INFILL INCENTIVE DISTRICT SUBMITTAL PACKAGE FOR:

10 E. BROADWAY BLVD

Permit Status: PLAN RFC **Activity Number:** DP15-0208 Permit Type: ADDING ADDITIONAL FLOORS TO EXISTING BUILDING, POSSIBLE TI

DATE: December 22, 2015 DUE DATE: December 29, 2015 SUBJECT: Add Floors TO: Richard Macias, PE

COVER SHEET DEVELOPMENT PACKAGE THE WESTERNER TUCSON LOT 3 BLOCK 216, M&P BK 3 PG 70, SECTION 13, T14S, R13E, G&SRM, PIMA COUNTY, AZ

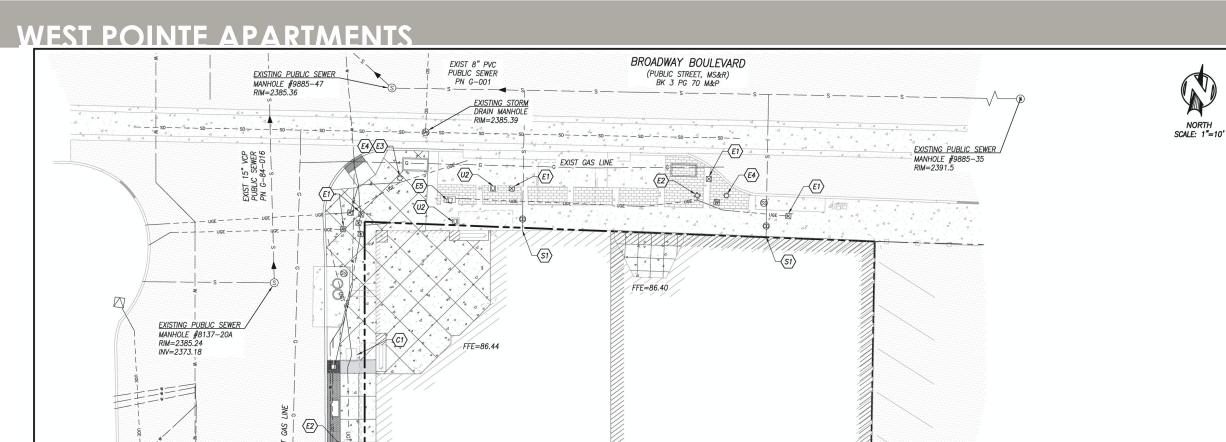
Point of clarification, Cover Sheet - IID notes: note 3, requesting relief from the lot coverage requirement. Based on UDC section 6.3.3.D.3, multifamily development does not have a lot coverage requirement. (I do not believe that relief for lot coverage is required.)

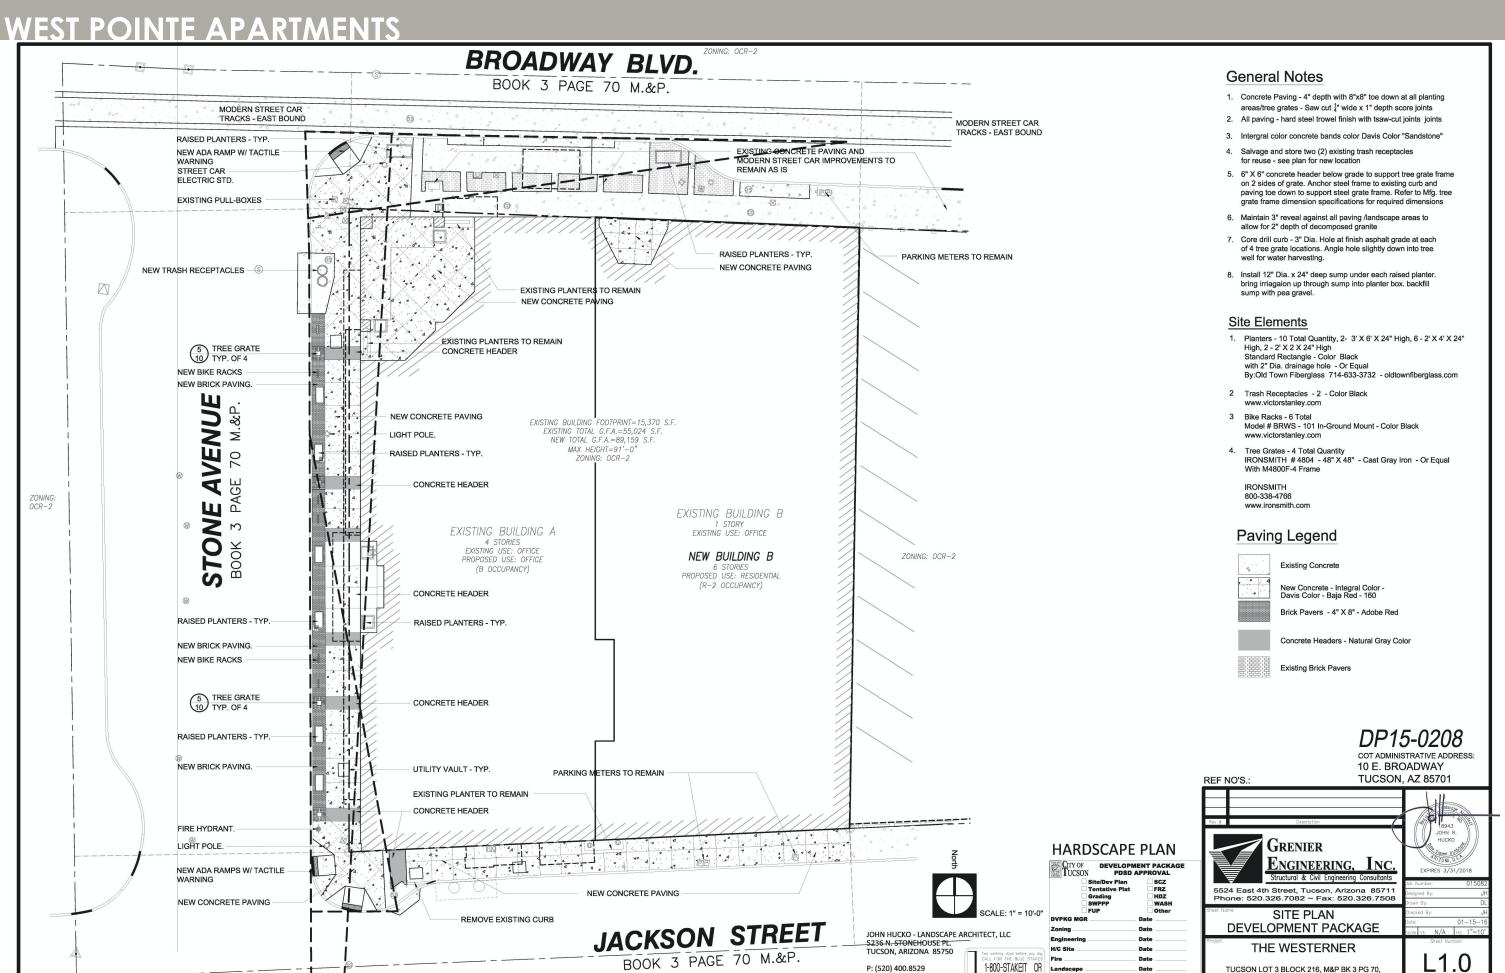
- 3) General note 38 refers to SWPPP. Please provide a copy of this plan for review with the next submittal.
- 4) Keynote 19 on sheet 4 refers to a "Turning vehicles yield to pedestrians" sign that is to remain. This sign is actually located across the street from where it is called out. The "right turn only" and "one way" signs are located as per the keynote 19 callout.

- 6) Per TSM 7-01.3.3B please show the accessible route, on sheet 4 between the new trash and recycle APC storage location as called out by keynote 32 and the trash APC pick up location in keynote 31. Please note that keynote 31 has a typo where the APC is referred to as ACP. Please correct.

- 7) There is concern that the 4.4 foot wide pedestrian access between the eastern most existing raised brick planter, as called out by keynote 13 on sheet 4, may not be sufficient to transport the 4 cubic yard waste container between its storage and pick up location.

- 8) Sheet 5 is calling out several existing roof drains to remain. However, there appears to be an existing roof drain on the east side of the new curb access ramp (see keynote 4 on sheet 4) that is not identified or notated as to whether it is to remain. Please
